**CITY OF HANOVER
PLANNING COMMISSION MEETING
MARCH 25, 2019
AGENDA**

SUBJECT: **River Town Villas of Hanover** for (1) Rezoning; (2) Planned Unit Development; and (3) Preliminary Plat

Subj: Planning Review Comments – River Town Villas
Preliminary Plat and Plans dated February 22, 2019

PRELIMINARY PLAT
C1-2

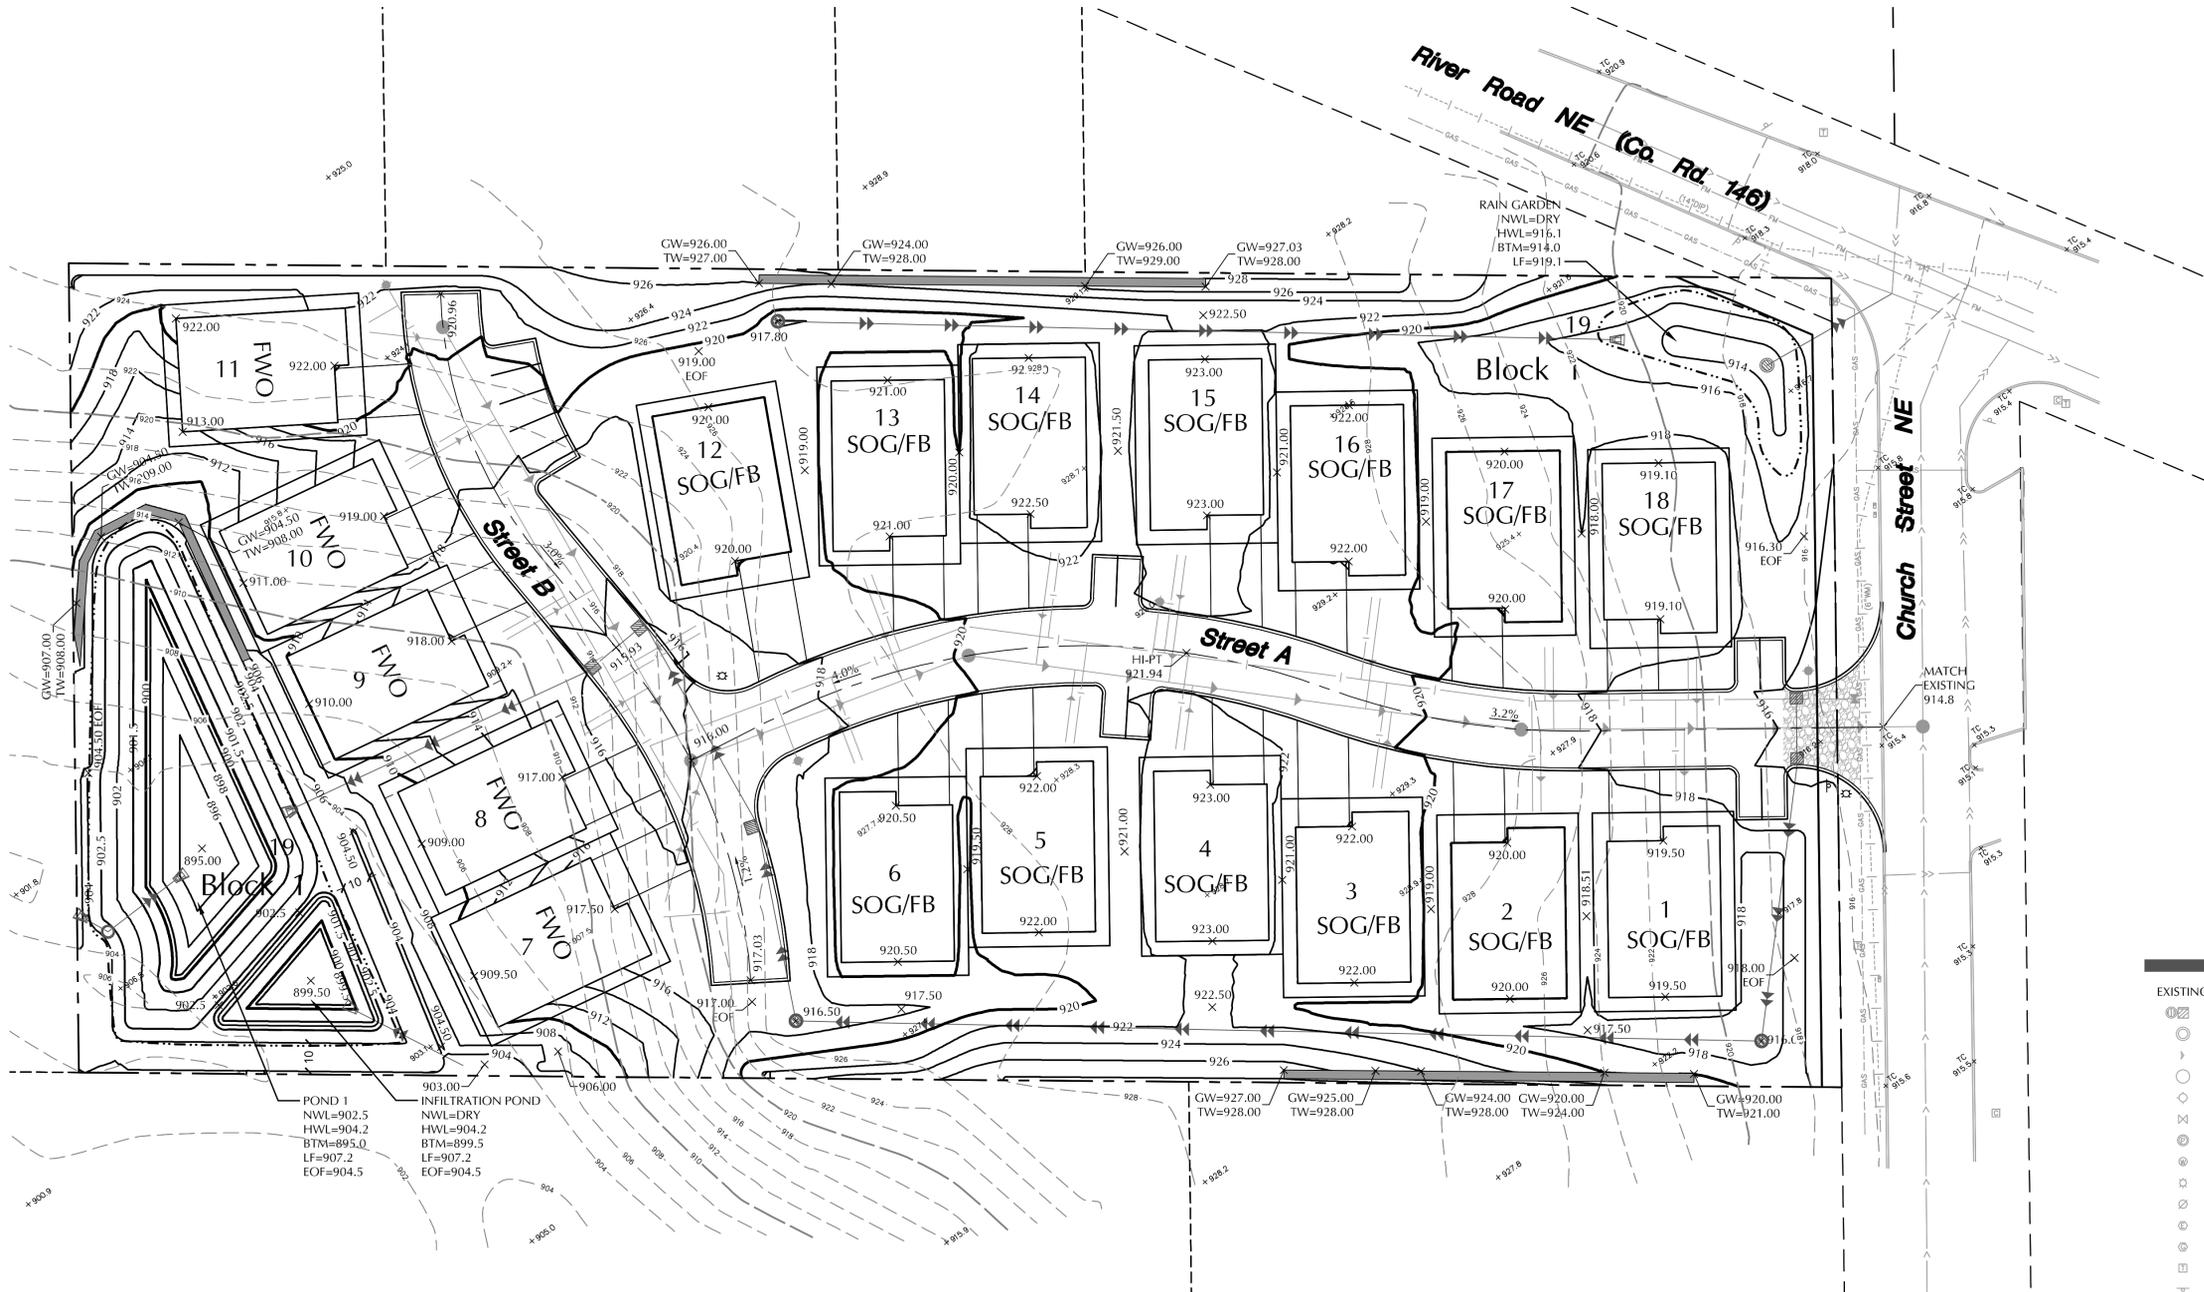
1. Density is preliminarily calculated at 4.82 units per acre, which is within the range allowed under the Comprehensive Plan (4 to 12 units per net acre in Multi-Family Residential). Comments in this memo and the City Engineer's memo may impact the density calculation, which will be recalculated at resubmission.

2. Addressing the comments contained in the City Planner and City Engineer staff memos may result in changes to or the removal of lots, outlots or easements.

6. It is our understanding that certain lots may have a greater depth when shown in the final plat. Please verify that under that revised scenario that the structures can still meet the setbacks as proposed in the PUD conditions prepared by the City Planner.

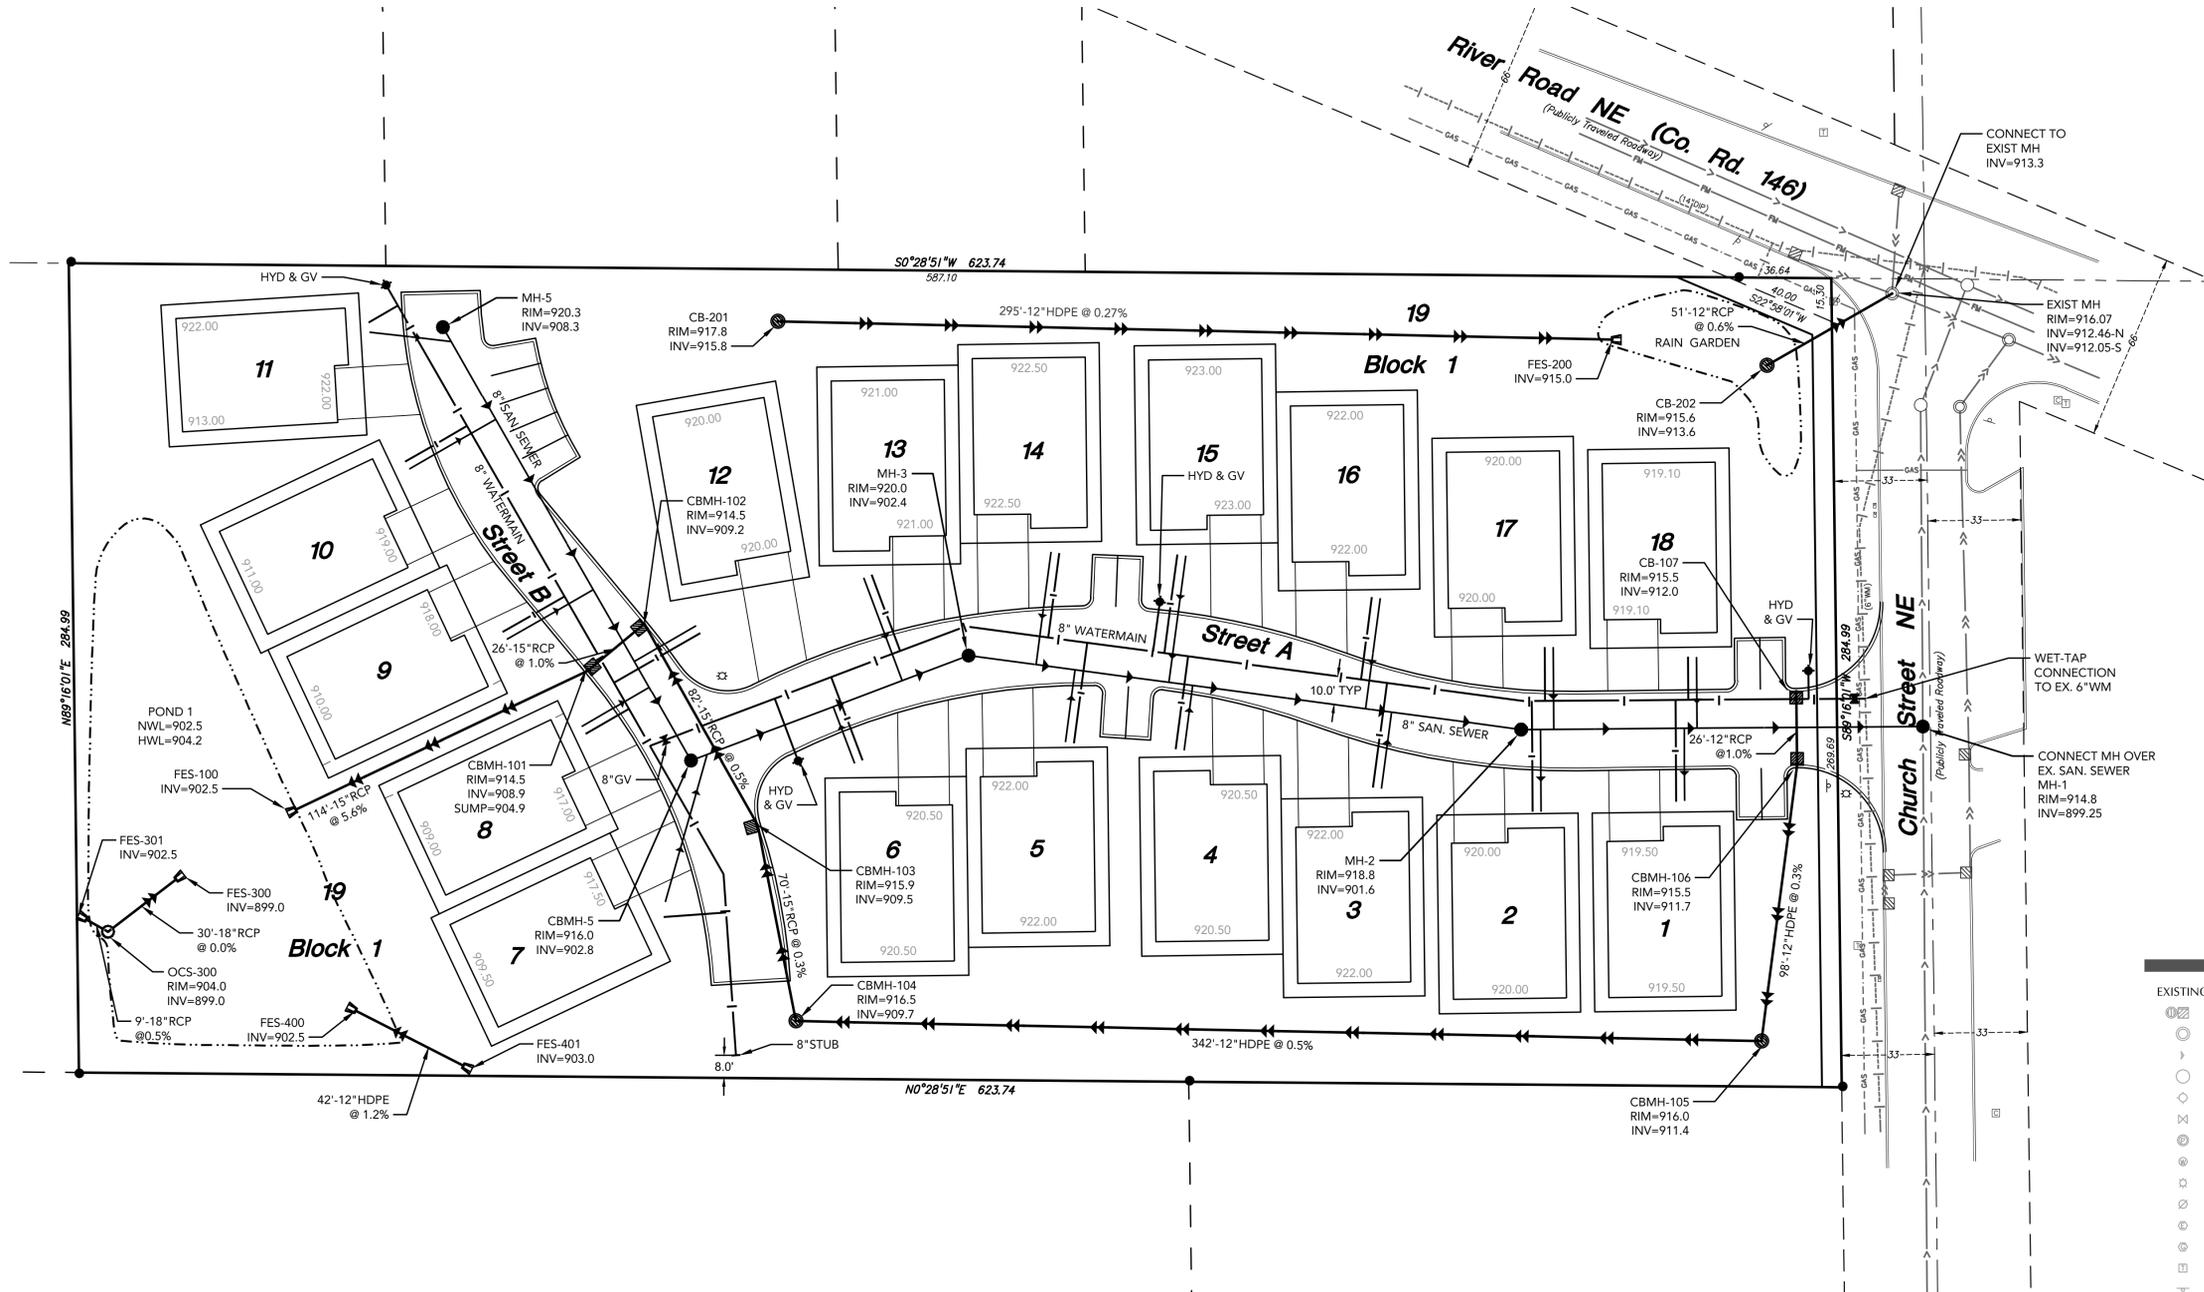
33. Describe and show the proposed extents of the roadway restoration associated with the connections to the existing utilities.
34. The proposed utility plan shows an 8" watermain connecting to the existing 6" watermain on Church Street NE. Verify the upsizing will maintain adequate pressures within the proposed development.

35. Show all water services on the upstream side of the sanitary services (e.g. lots 5,6,8,13,14).
36. Show a gate valve after the connection to the existing watermain at Church Street NE in accordance with City Detail WAT-03.

37. Show proposed curb stops for the development. Place them 10' behind the back of curb in accordance with City Detail WAT-04.
38. Replace the 8" stub at the west end of Street B with a hydrant and gate valve.

39. Provide an additional gate valve at the intersection of Street A and Street B.
40. Provide service risers for the sanitary sewer services on Street A.

42. CB-201 & CB-202 are only 2' deep which presents concerns with frost heave. Consider using structures with filled or unfilled sumps to provide additional depth.

43. There is as little as 1' of cover over portions of the pipe from CB-201 to FES-200.
44. With the submittal of final plat and construction plans a minimum 18 inches of separation and insulation per City Detail WAT-06 will need to be shown between the watermain and all sewer crossings.

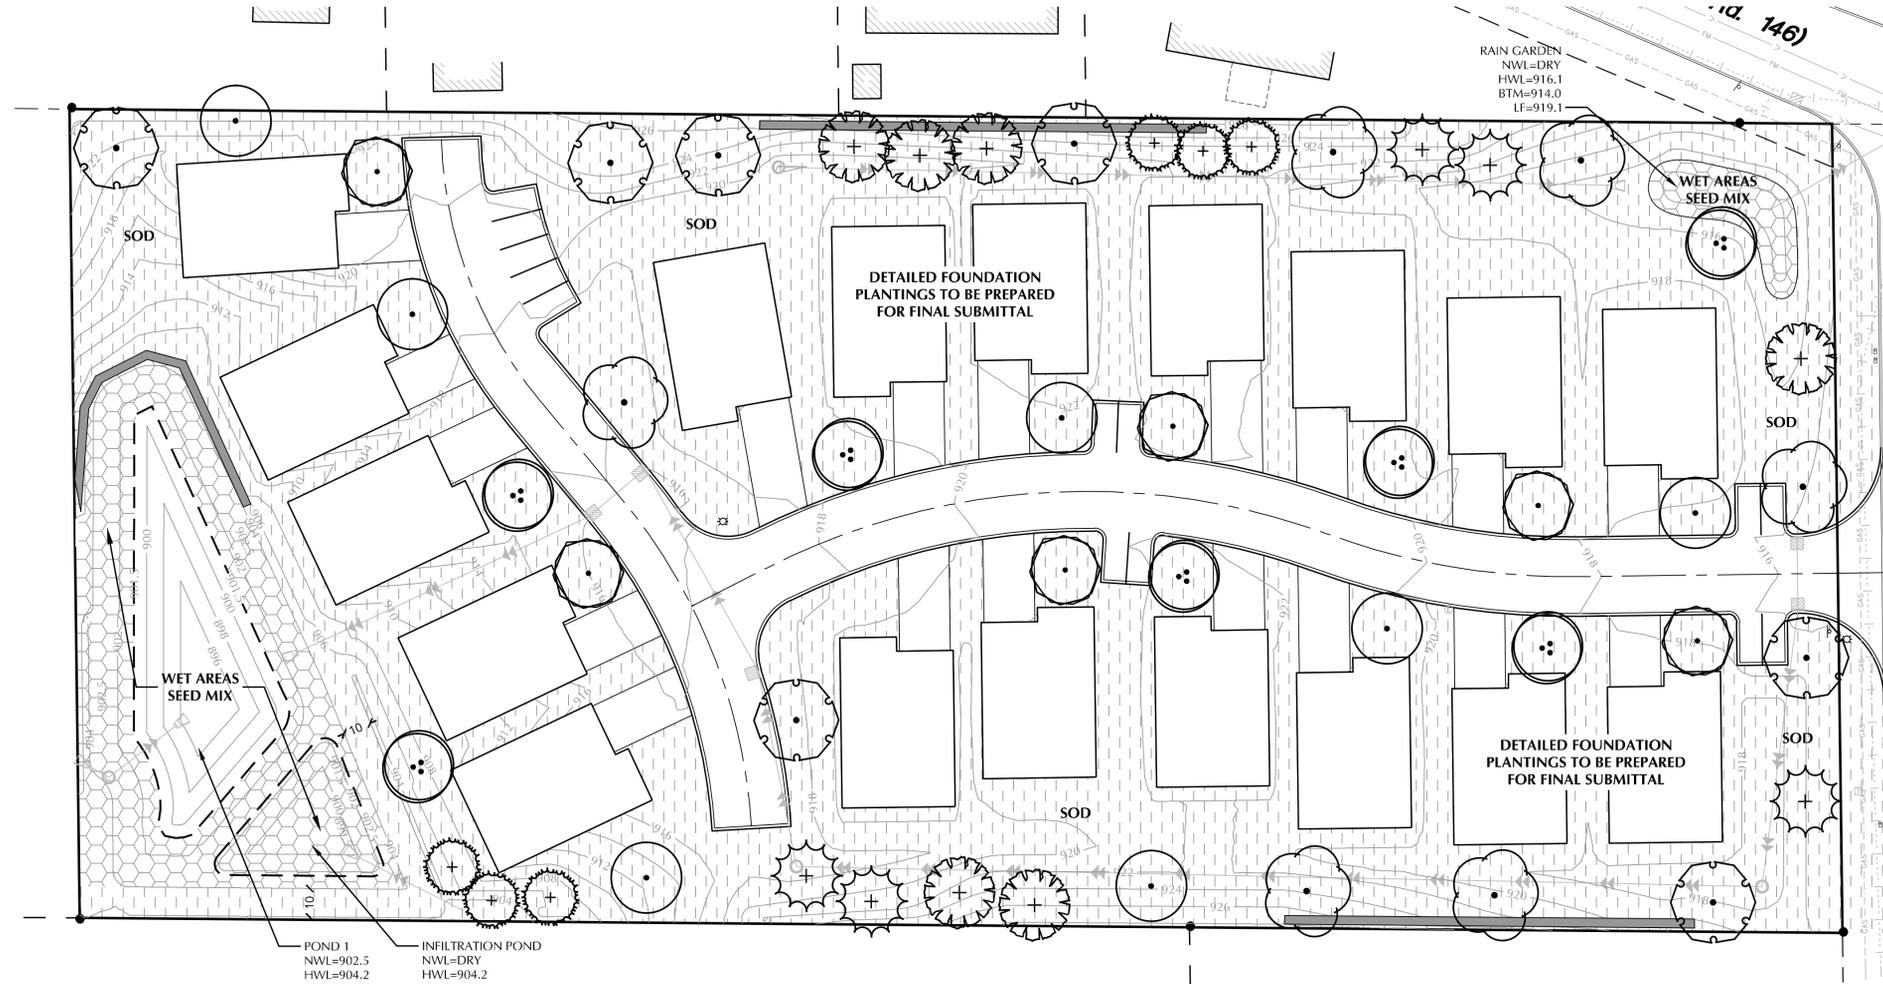
18. There are trees proposed within a few feet of the storm sewer (e.g. west end of Street B near CBMH-104). All trees should be a minimum of 10 feet from the storm sewer system to protect the storm sewer and prevent trees from needing to be removed with future maintenance.
19. Verify boulevard site distances are being met with the two trees located at the entrance (see City Detail STR-26).

7. Street trees are required in addition to two trees per lot (30-08-06, A.33). Verify that all street trees are at least 30 feet from the any intersection. In addition, on the side of any street without a sidewalk, street trees must be at least five feet from the curb. This requirement will be reviewed for compliance with final plat submissions.
8. Locations for mailbox clusters should be identified on the plans.
9. A foundation and grading as-built for each home will be required as a condition of approval of the Planned Unit Development.
10. Signage approved by the City will need to be placed along lot lines or corners next to storm ponds or wetlands.
11. Deeds for conveyance of the stormwater outlots to the City shall be coordinated with final plat recording.
